MANDATORY SERVICE BULLETIN**NUMBER:** SB-010 **AMENDMENT 1****DATE:** 06/09/2009**SUBJECT:** FUSELAGE; VERTICAL TAIL BOLT INSPECTION **AMENDMENT 1****SUMMARY**

This is an amendment to SB-010 for the mandatory Vertical Tail Bolt Inspection of the KODIAK 100. Quest has discovered that the washer part number callout in the previous Service Bulletin was incorrect and is reissuing work instructions with the correct part numbers identified.

**SB-010 Vertical Tail Bolt Inspection
AMENDMENT**

Figure 1 - Bolt Locations

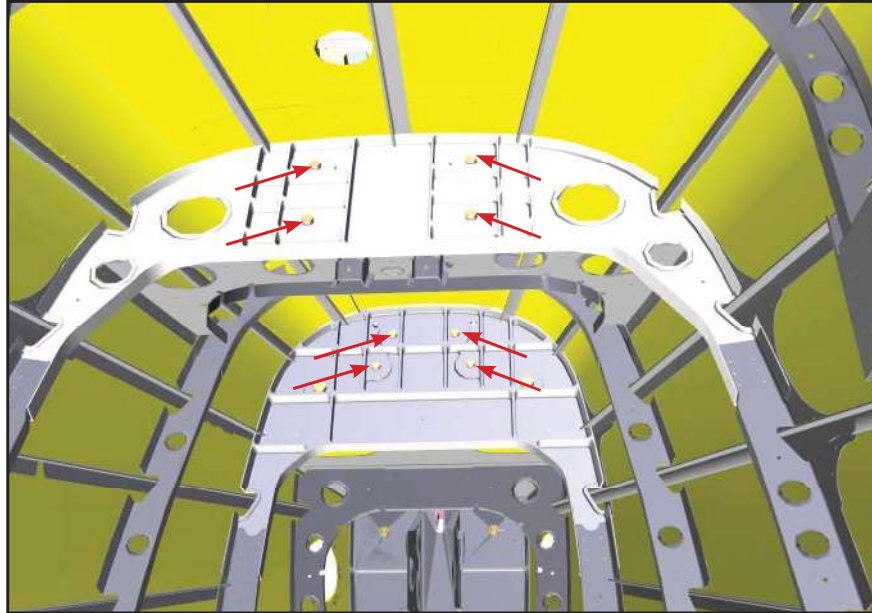
Locate the **8** vertical tail attachment bolts.

See **Figure 1** for assistance in identifying these 8 bolts within the vertical tail. **Figure 2** shows a close-up view of the bolts that must undergo inspection.
